Road & Bridge Design Publications

Monthly Update - November 2011

Revisions for the month of **November** are listed and displayed below. New special details are to be included in projects submitted for the **February** letting as is stated on the special detail index sheets. Please contact Wayne Pikka (pikkaw@michigan.gov) for any questions related to the road changes and Vladimir Zokvic (zokvicv@michigan.gov) for questions related to the bridge changes.

F.H.W.A. APPROVAL	11-9-2011 PLAN DATE	R-45-I	SHEET 1 OF 2

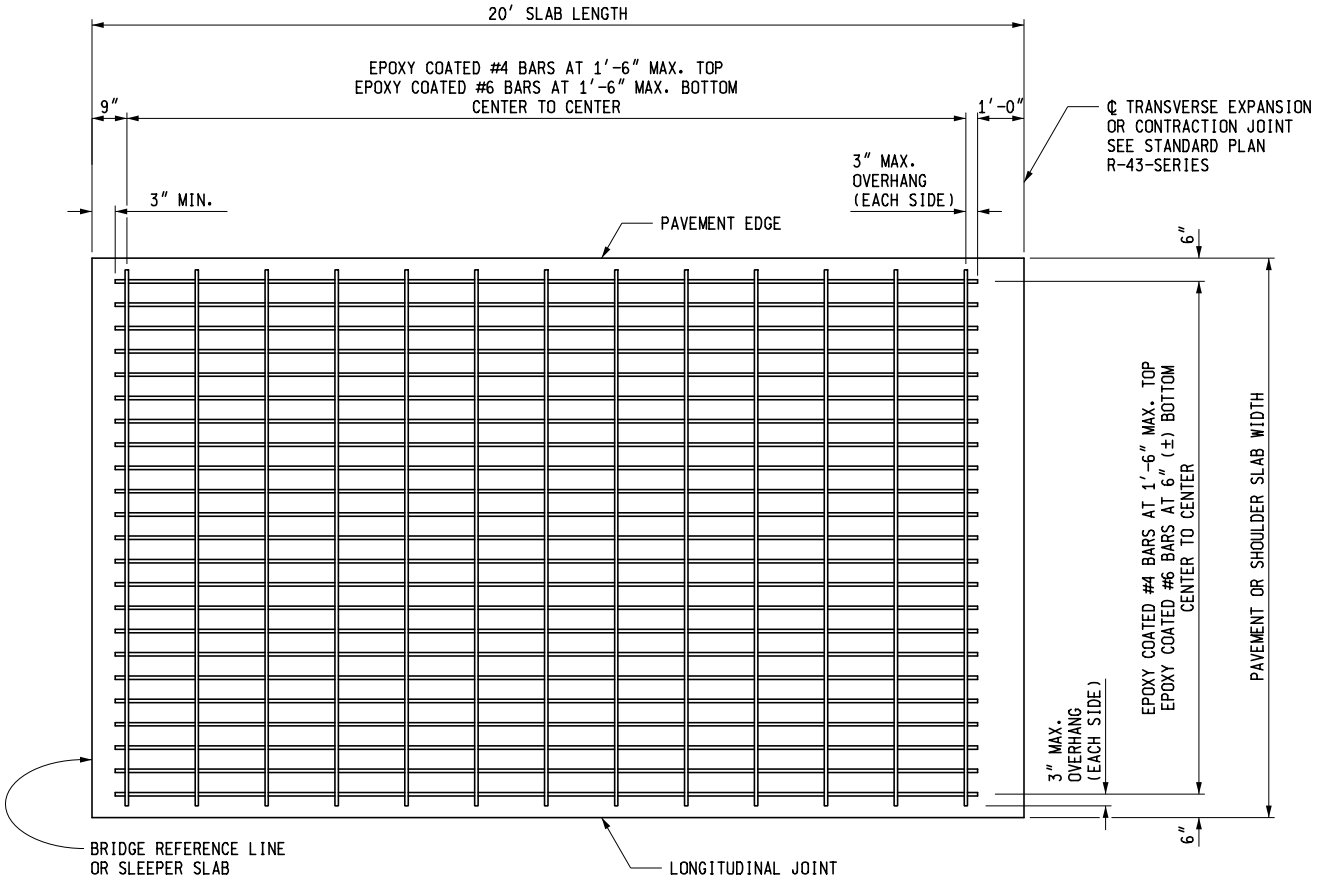
R-45-I: Pavement Reinforcement for Bridge Approach: On sheet one, the size of the top reinforcing bars was reduced. The reinforcement spacing increased, except for the bottom longitudinal bars. The distance from the reinforcement to both the load transfer assembly and the edge of slab was decreased. A steel reinforcement chart replaced slab width and steel reinforcement data in note form. Details for expansion and contraction joints were eliminated in favor of a detail "A", now located on sheet two. A note was added in regards to skewed bridges. On sheet two, a sketch employing a sleeper slab was created to detail pavement and shoulder slabs adjacent to structures.

PREPARED BY DESIGN DIVISION	5.21.01

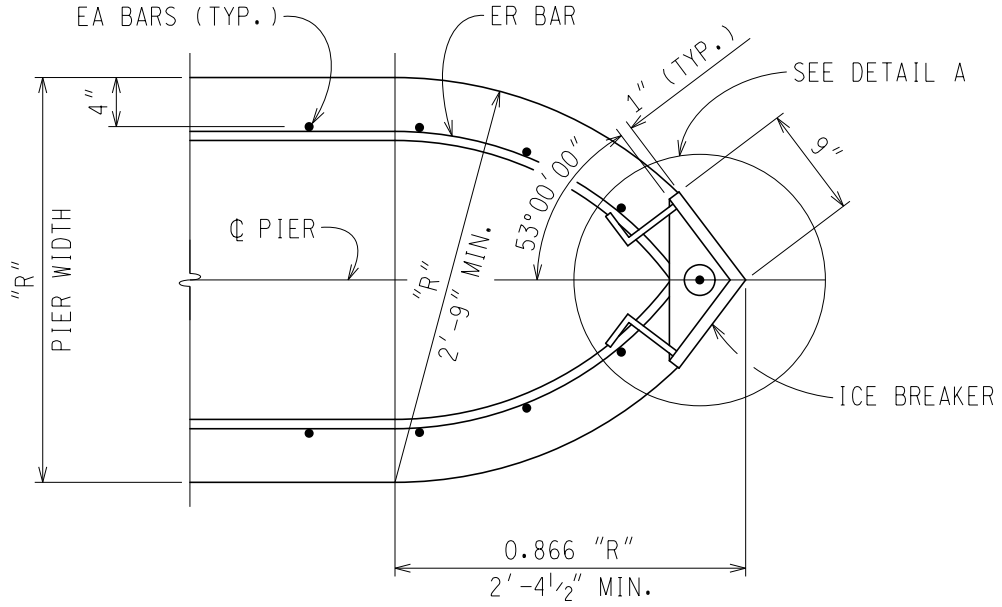
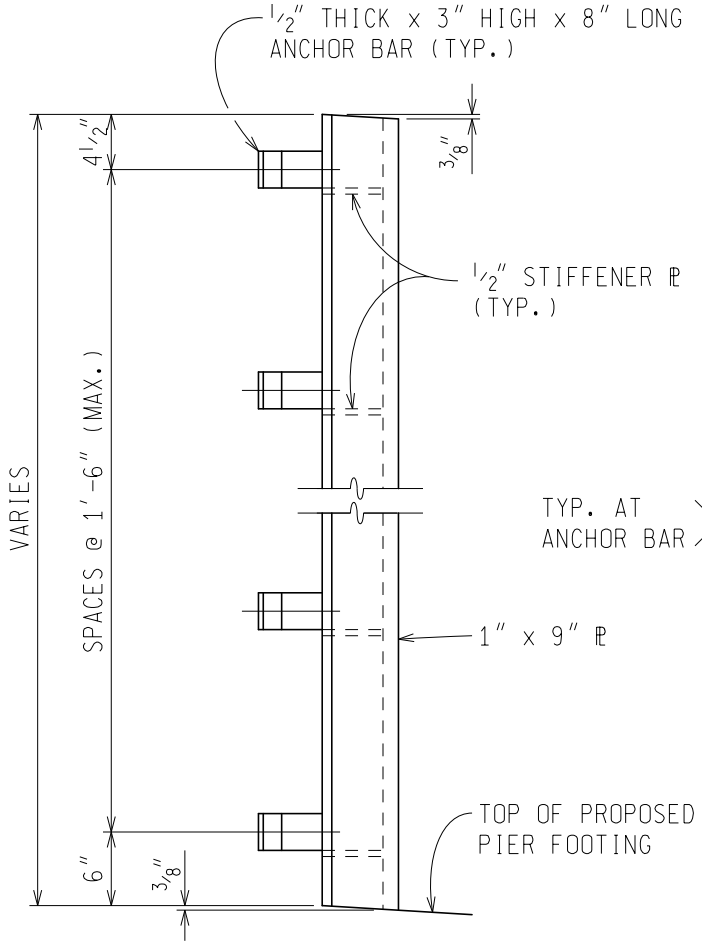
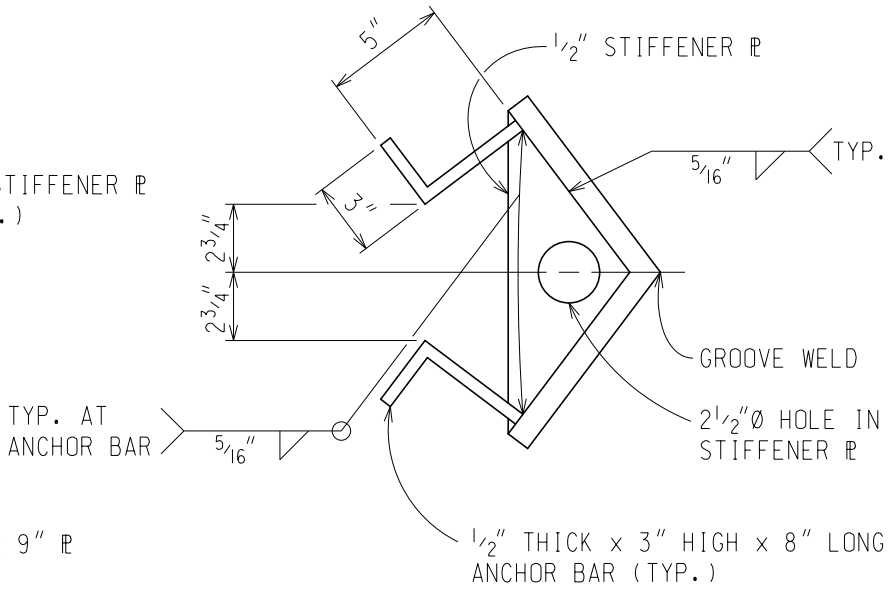
5.21.01: Better defined and detailed the pier nosing 3” x 8” anchor bar.

TYPICAL SECTION THRU SLEEPER SLAB WITH CONCRETE APPROACH

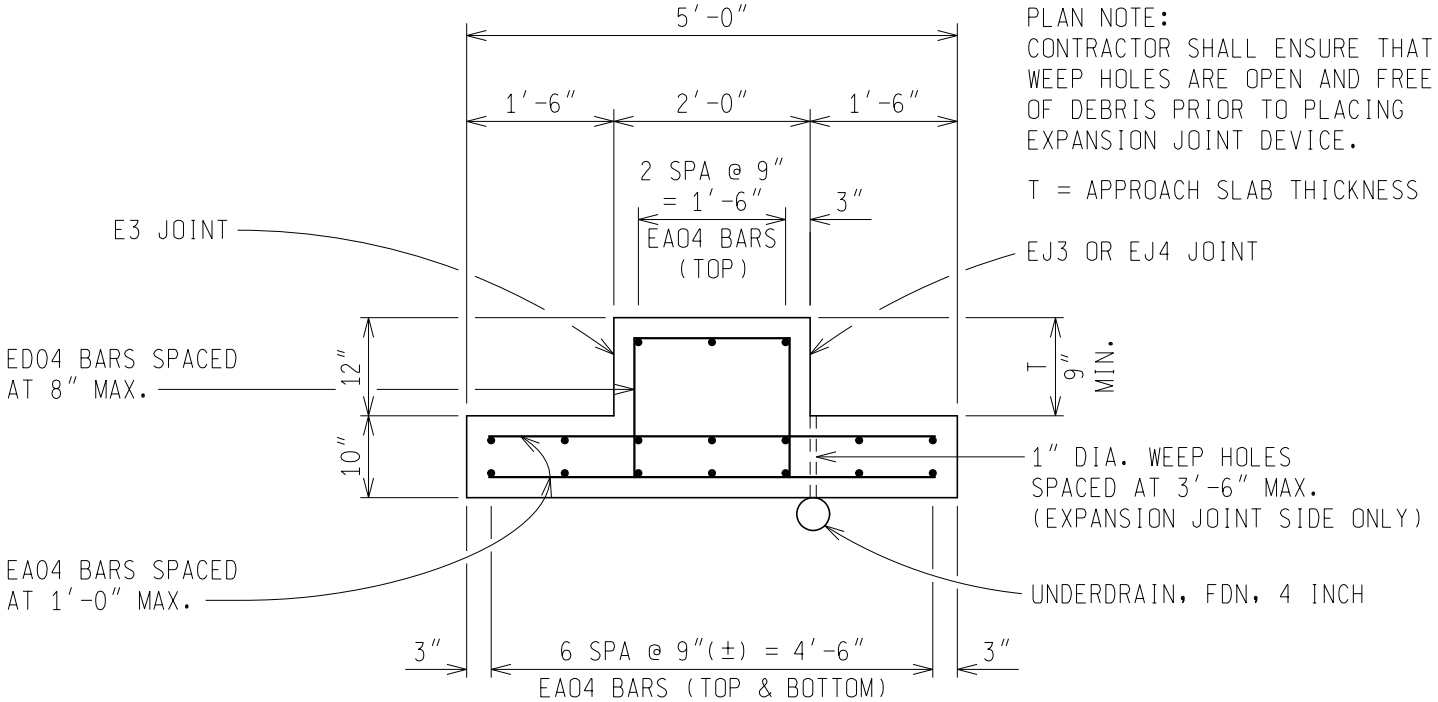
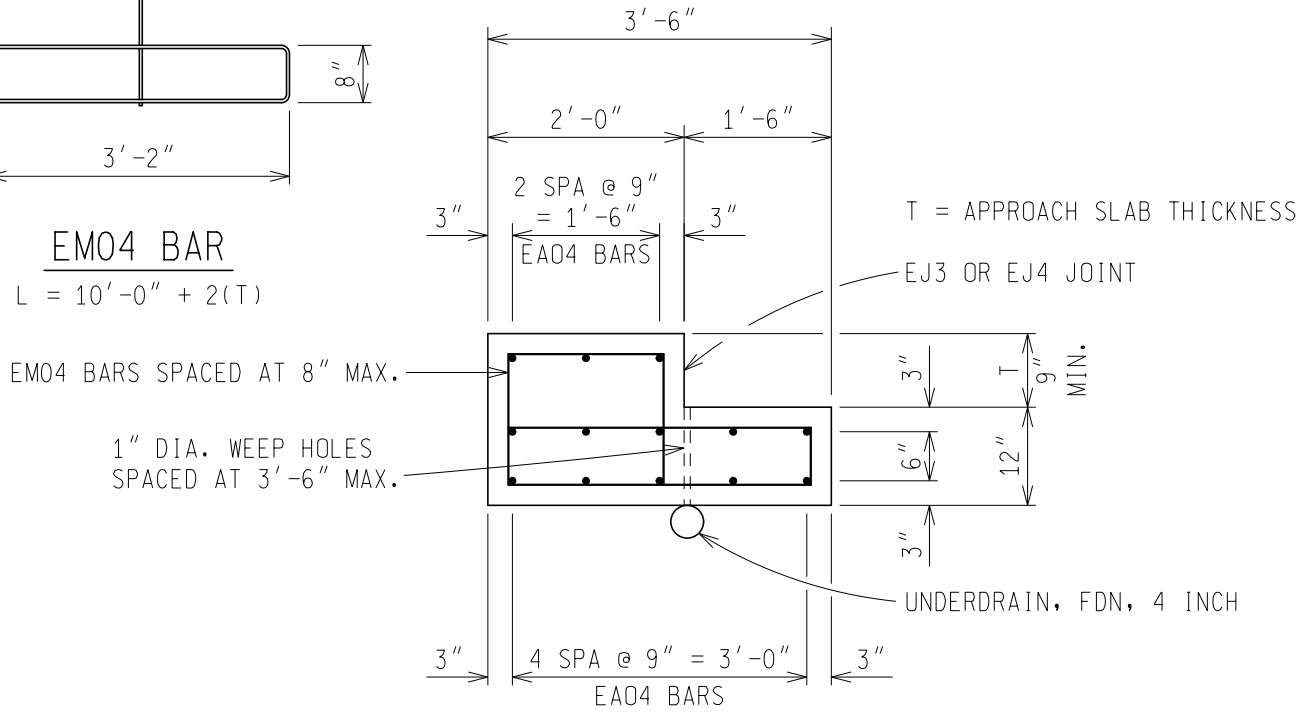
6.20.04 C: Updated the sleeper slab approach pavement depth. Depth is always 12” to correspond to Standard Plan R-45-Series.
